Point Beach Nuclear Plant, Units 1 and 2
Dockets 50-266 and 50-301
Renewed License Nos. DPR-24 and DPR-27

Supplement to License Amendment Request 252
Technical Specification 5.6.5, Reactor Coolant System (RCS)
Pressure and Temperature Limits Report (PTLR)

**MARK-UP OF TRM 2.2
PRESSURE TEMPERATURE LIMITS REPORT**

Figure 1
RCS PRESSURE-TEMPERATURE LIMITS FOR HEATUP

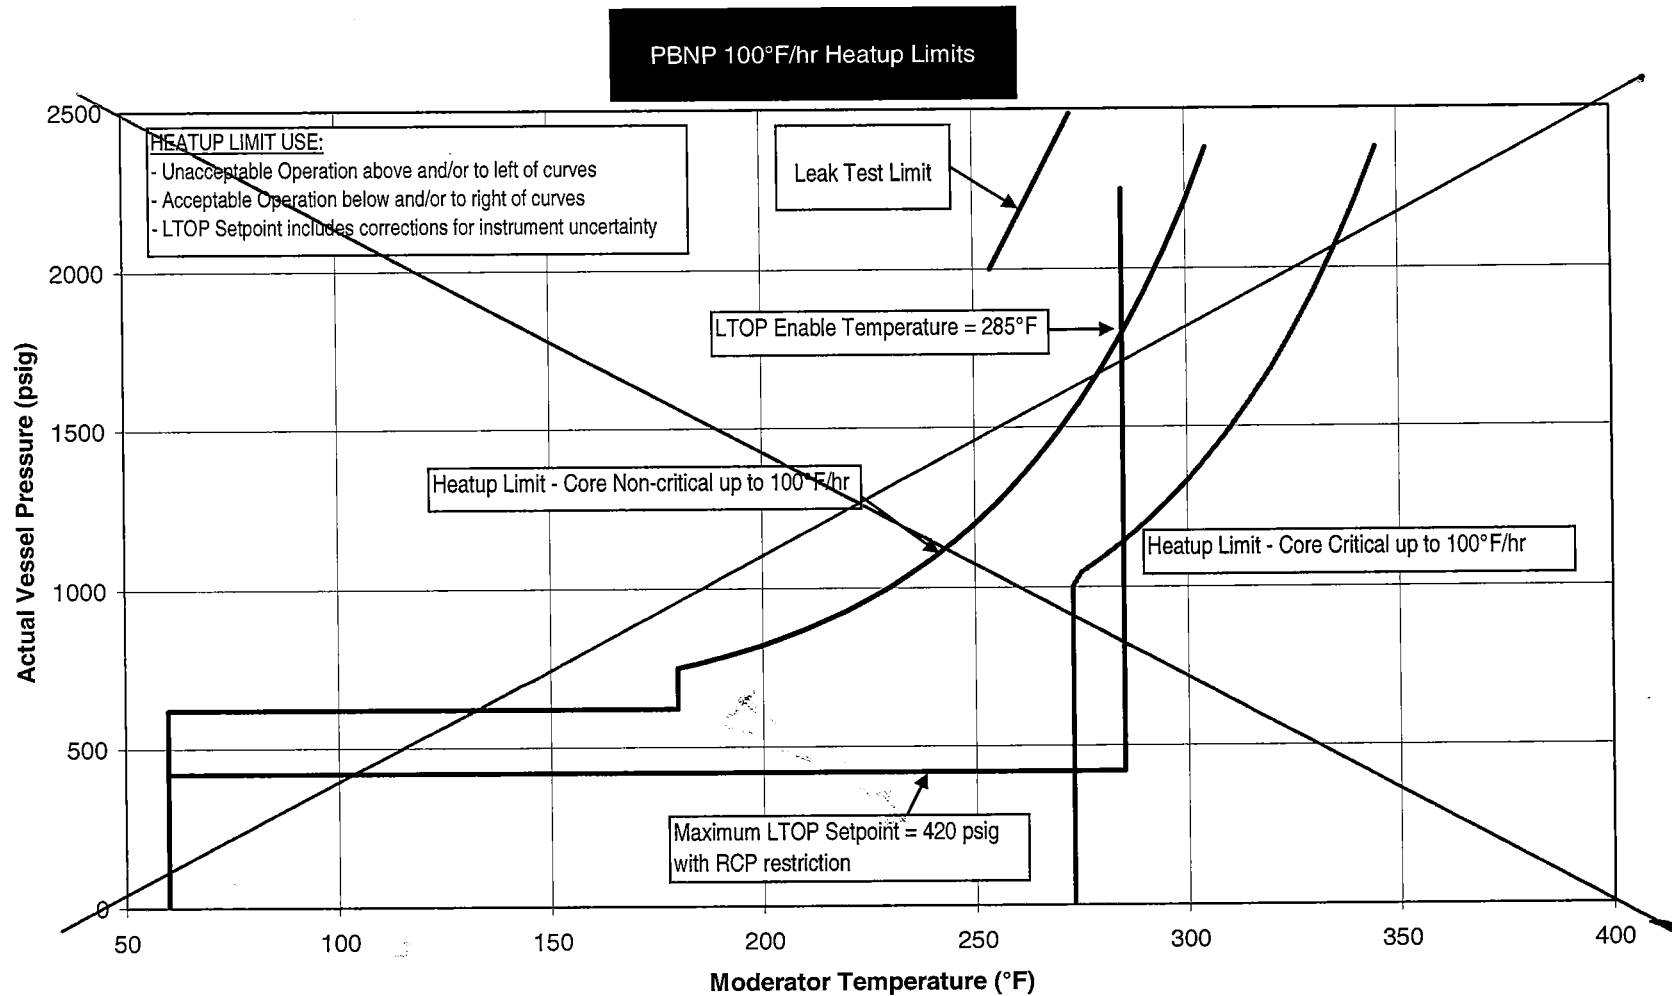
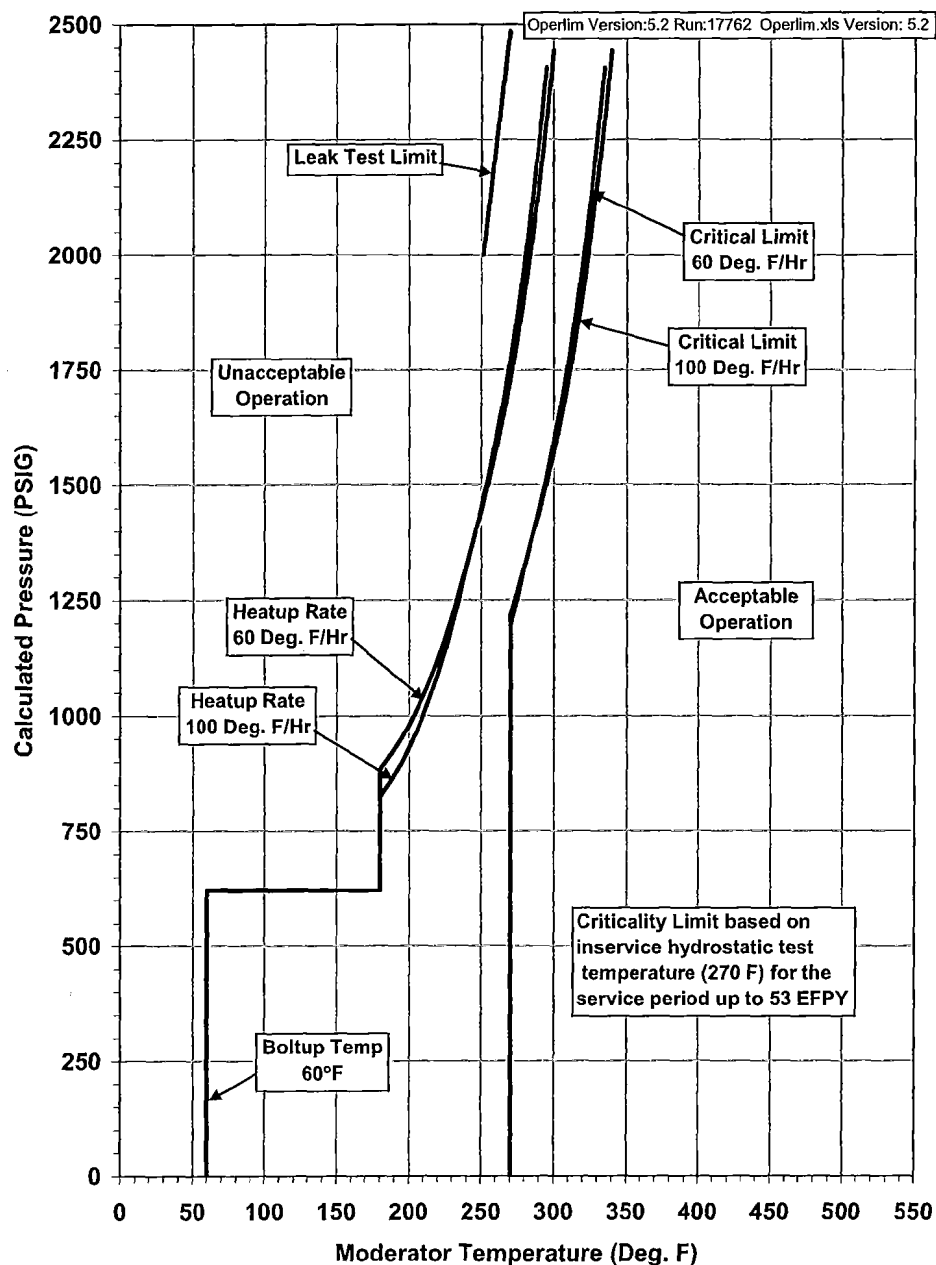
REPLACE FIGURE WITH FIGURE 5-7 OF WCAP-16669-NP

Figure 5-7 Point Beach Units 1 and 2 Reactor Coolant System Heatup Limitations (Heatup Rates of 60 and 100°F/hr) Applicable for 53 EFPY (with Hafnium Removal and without Margins for Instrumentation Errors) Using 1998 App. G Methodology (w/ K_{IC})

Figure 2
RCS PRESSURE-TEMPERATURE LIMITS FOR COOLDOWN

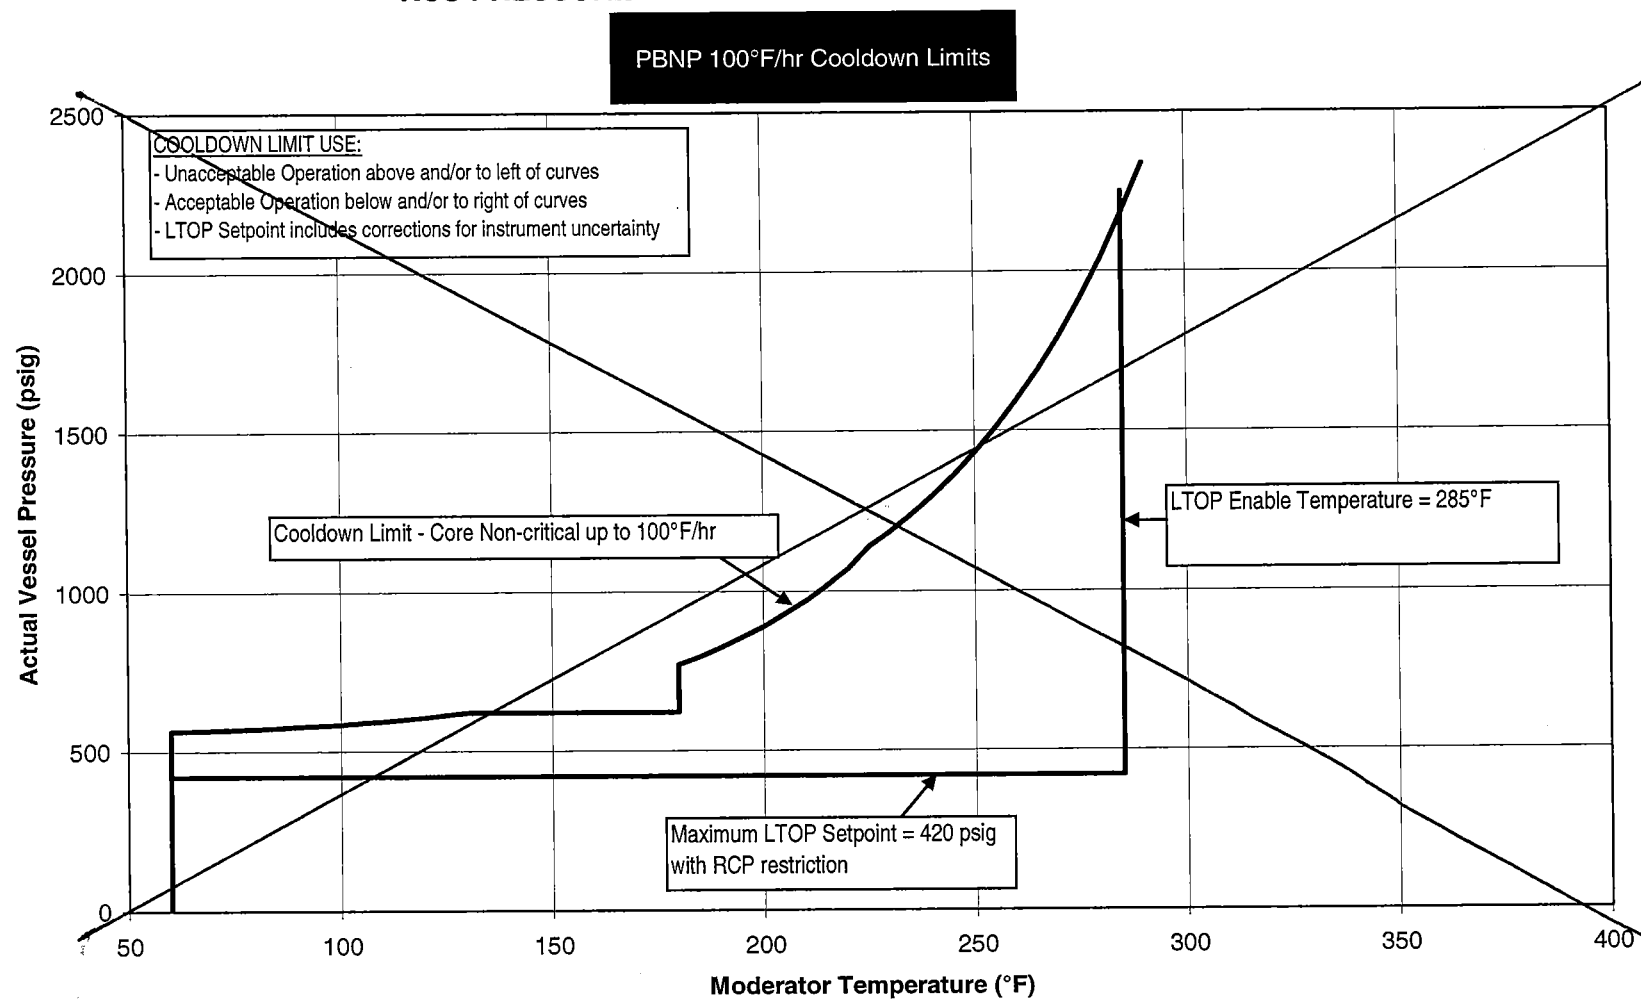
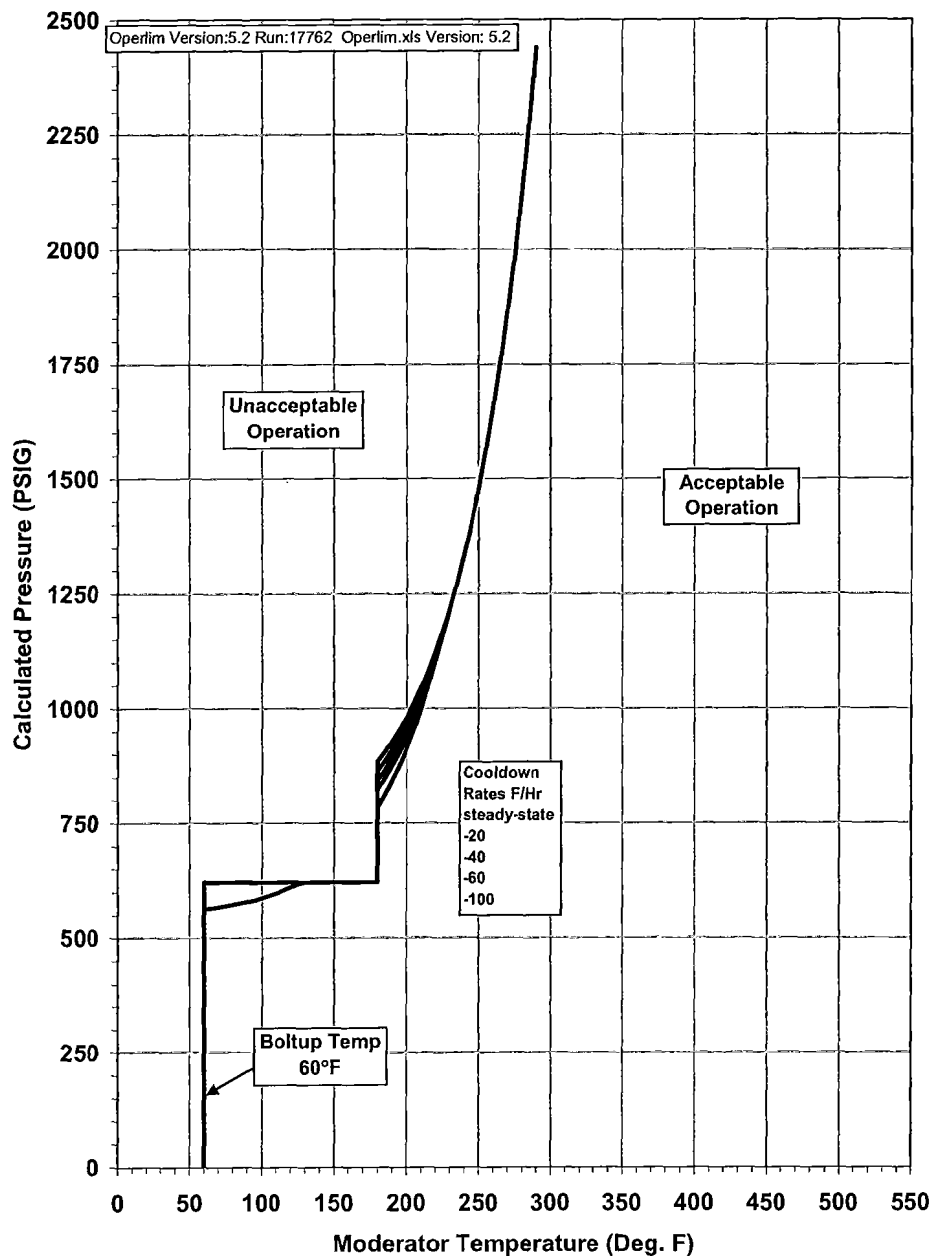
REPLACE FIGURE WITH FIGURE 5-8 OF WCAP-16669-NP

Figure 5-8 Point Beach Units 1 and 2 Reactor Coolant System Cooldown Limitations (Cooldown Rates up to 100°F/hr) Applicable for 53 EFY (with Hafnium Removal and without Margins for Instrumentation Errors) Using 1998 App. G Methodology (w/K_{IC})
